Response to the comments in Table 24.1 of the CBRE follow-up review.

Figure 2: Wind Conditions of the Proposed Development with Existing Surrounding Buildings

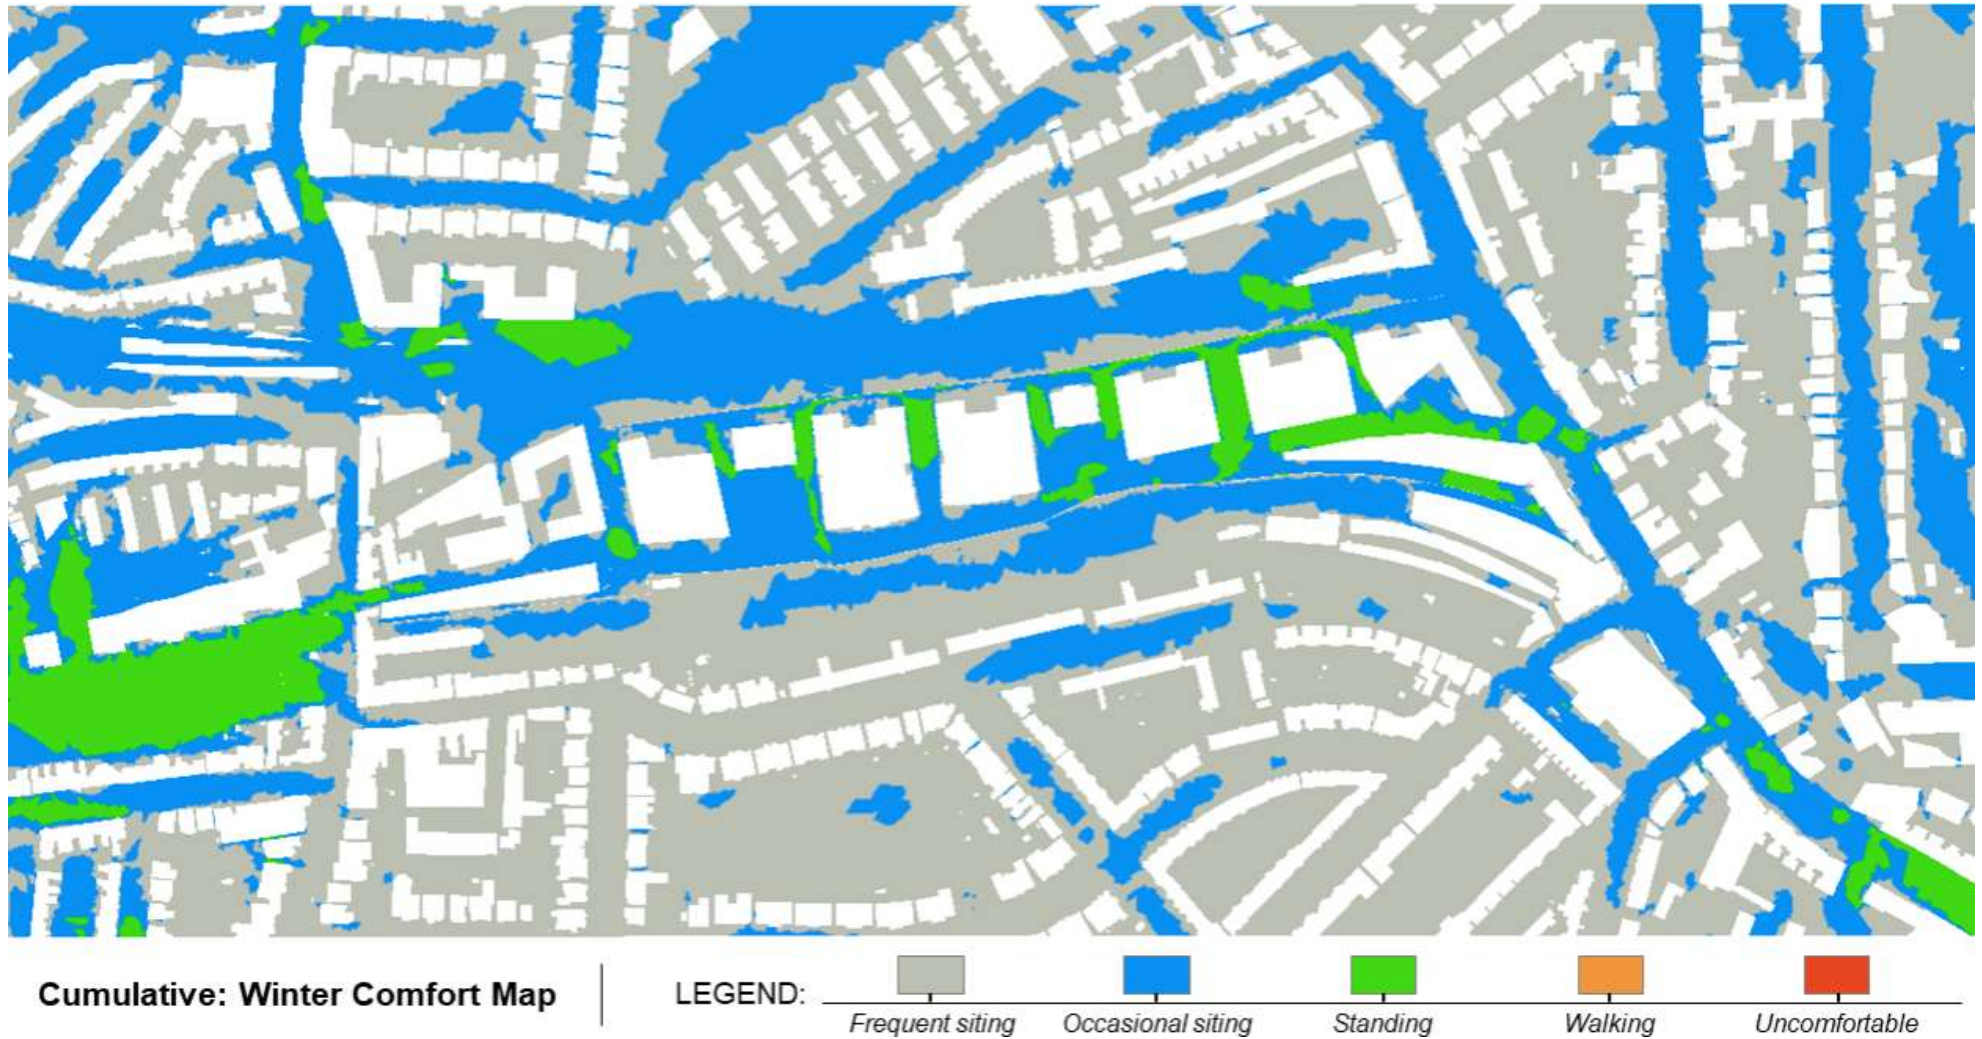
This is not an accurate explanation of the significant methodology set out in the ES chapter. Significance is not only dependent on whether conditions are uncomfortable or unsafe, it is also dependent on whether the comfort category has changed from the baseline. With the higher resolution images that have now been provided, it is clear that comfort conditions have deteriorated in a number of areas to the north and south of the application site. For example, in some areas, the wind comfort maps show that conditions have deteriorated from frequent sitting to occasional sitting, while others have deteriorated from occasional sitting to standing. In a small area to the north, it appears that conditions have deteriorated from frequent sitting to standing (a two comfort category deterioration).

The definition of a moderate adverse effect in the methodology section of the chapter is "Conditions that were 'suitable' in terms of comfort in the baseline scenario are made windier (by at least one comfort category) as a result of the Proposed Development but remain 'suitable' for the intended pedestrian activity. The results indicate that a number of moderate adverse effects are caused by the scheme in the surrounding area. The applicant should review the results in line with these comments and update the chapter as necessary. As previously requested, the Applicant should also include in the chapter the sensitive uses in the surrounding area as these must be understood so it can be confirmed whether conditions are suitable at these locations so the significance can be correctly assessed.

The areas that would deteriorate to the north and south of the application site would fall onto areas of heavy vegetation (which were not modelled to assess the worst-case scenario) and rail tracks. Therefore, wind conditions in those areas were not discussed in the assessment as they are inaccessible to pedestrians.

Two small areas to the south of the tennis courts on Lymington Road and at the junction of Broadhurst Gardens and Priory Road would be one category windier than the Baseline representing a Minor Negative effect but would remain below the 'standing' target and as such would be suitable for the intended pedestrian use.

The majority of wind conditions at bus stops would be similar to the Baseline scenario representing a negligible (not significant) effect. The exception to this would be at bus stops located to the north of Finchley Road (relative to the Proposed Development) (See Figure 4 for

locations, which would be one category calmer than the baseline representing a Minor Positive (not significant) effect.

The majority of wind conditions at pedestrian crossings would be similar to the Baseline scenario representing a negligible (not significant) effect. The exception to this would be at pedestrian crossings located to the north of Finchley Road (relative to the Proposed Development), which would be one category calmer than the baseline representing a Minor Positive (not significant) effect.
